United States Patent and Trademark Office

APPLICATION NO.	FII	LING DATE	FIRST NAMED INVENTOR	ATTORNEY DOCKET NO.	CONFIRMATION NO.	
10/036,531	0	1/07/2002	Robert Frigg	8932-591	4875	
20582	7590	01/21/2004		EXAMINER		
JONES DA			COMSTOCK, DAVID C			
51 Louisian WASHING		.W 20001-2113		ART UNIT PAPER NUMBER		
	,			3732		
				DATE MAILED: 01/21/2004	9

DETAILED ACTION

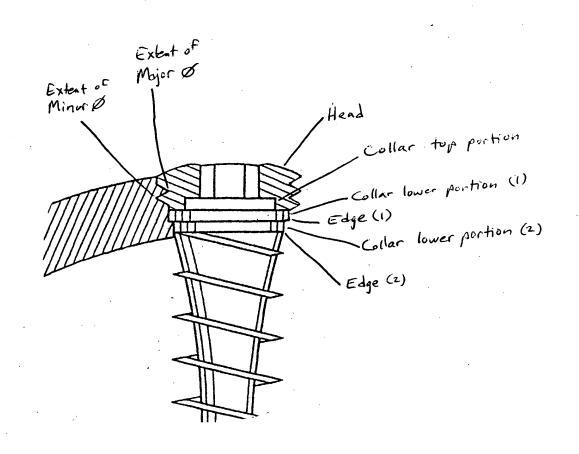
Michelson shows a device comprising a bone fastener having a shank 170, a head 300, and a collar. (See Figs. 64-66 and Attachment A.) The head comprises a convex, semispherical top portion (see Fig. 64). The collar has three circular, disk-shaped portions, a top portion and two lower portions. Each of the portions of the collar has a constant diameter. The lower portions form two edges which are circular and substantially sharp, i.e., not rounded. The edges define two rings, i.e., the sides of the collar lower portions. The circular edges of the lower portions contact an inner surface of a bore 602 in a receiving member 600 (see Figs. 63 and 65). The bore comprises a first portion of constant diameter, i.e., the portion housing collar lower portion (1), and a second threaded portion having two diameters, a thread major diameter and a thread minor diameter (see Fig. 66 and Attachment A). The head is removably seated on the collar and shank. The receiving member has a channel 670 extending transverse to a

central axis of a bore. The channel receives a longitudinal support 54,106 (see Figs 39 and 63). The lower contour of the collar lower portion (1) defines a radial extent of a plane bearing surface, i.e., the underside of the collar lower portion (1) (see Fig. 66 and Attachment A).

Michelson shows a device comprising a bone fastener having a shank 170, a head, and a collar. (See Figs. 65, 66 and Attachment B.) The collar has a top portion and two circular, disk-shaped lower portions. Each of the portions of the collar has a constant diameter. The lower portions form two edges which are circular and substantially sharp, i.e., not rounded. The edges define two rings, i.e., the sides of the collar lower portions. The circular edges of the lower portions contact an inner surface of a bore 602 in a receiving member 600 (see Figs. 63 and 65). The bore comprises a first portion of constant diameter, i.e., the portion housing collar lower portion (1), and a second threaded portion having two diameters, a thread major diameter and a thread minor diameter (see Fig. 66 and Attachment B). The head is integrally formed as the end of the shank. The receiving member has a channel 670 extending transverse to a central axis of a bore. The channel receives a longitudinal support 54,106 (see Figs 39) and 63). The lower contour of the collar lower portion (1) defines a radial extent of a plane bearing surface, i.e., the underside of the collar lower portion (1) (see Fig. 66 and Attachment B). A grub screw 300 releasably and threadably locks the fastener with respect to the receiving member (see Figs. 63-66 and Attachment B).
